Specification Mintech./CV2362 - CV2368
 Issue 2A, Dated September 1967
 To be read in conjunction with K1001
 ignoring clauses:- 5.2, 5.3, 5.8.

SPECIFICATION Mintech./CV2362-CV2368, ISSUE 2A, DATED SEPTEMBER 1967.

AMENDMENT No.1

ELECTRONIC VALVE SPECIFICATIONS
SPECIFICATION MINTECH/CV2362 - CV2368,
ISSUE 2A, DATED SEPTEMBER 1969
AMENDMENT NO 2

Page 5. Outline Drawing.

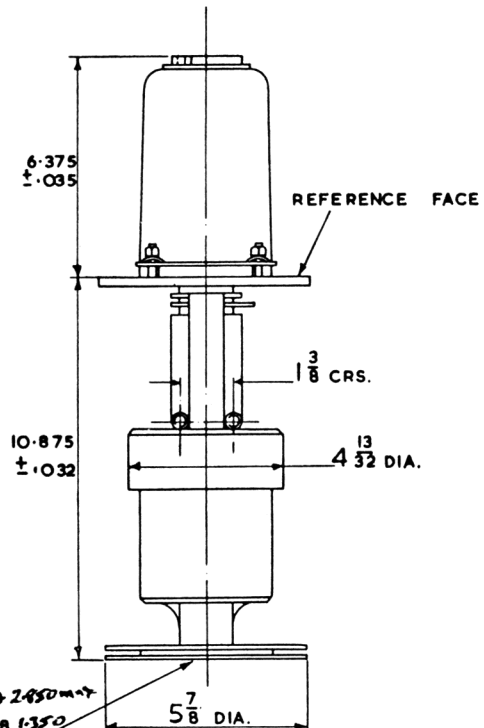
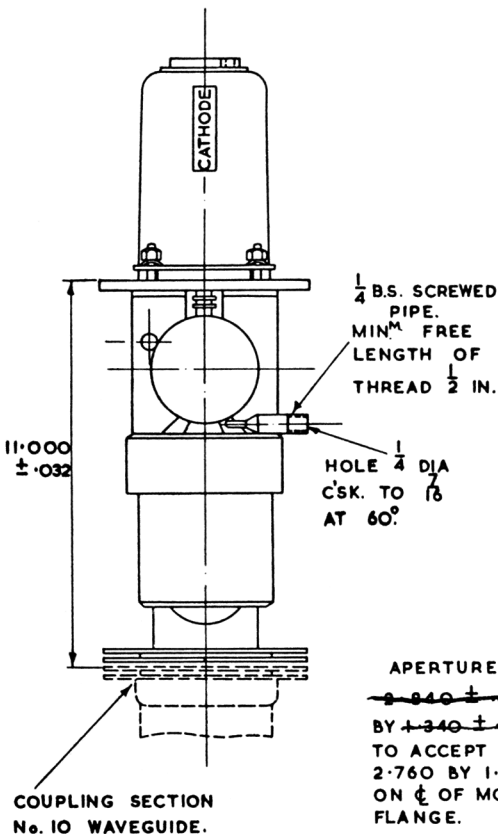
View in top right hand corner.

The flange diameter is shown as "6.000 Dia + .000"
- .000
which should be amended to read "6.000 Dia + .000"
- .010.

PAGE 1 Text, headed 'Aperture' (bottom centre of page)

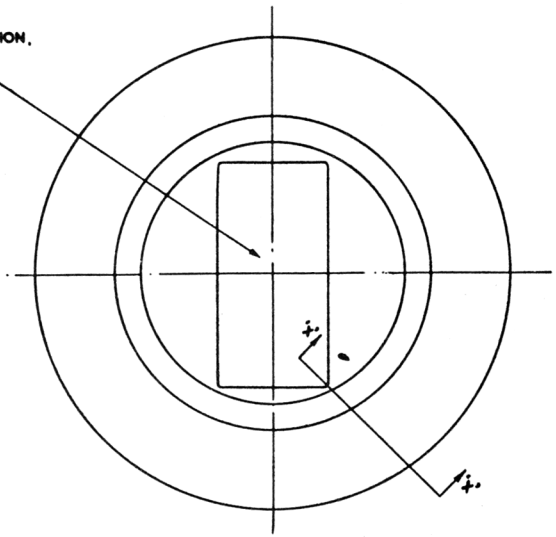
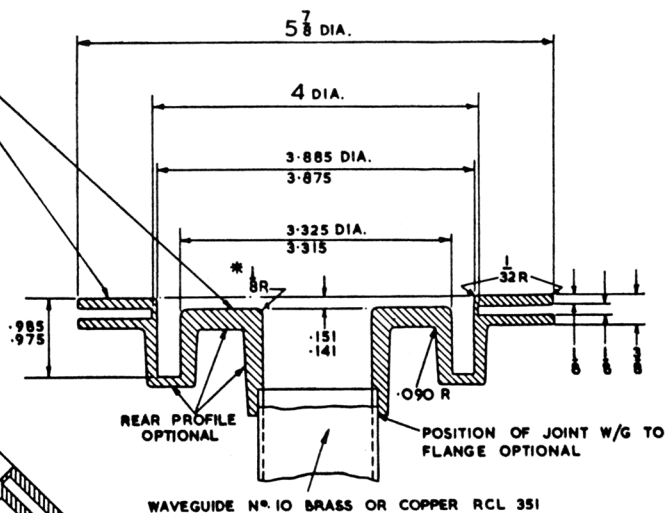
Delete the first two lines of the text " $2.840 \pm .008$ by $1.340 \pm .008$ " and insert " 2.850 max by 1.350 max"
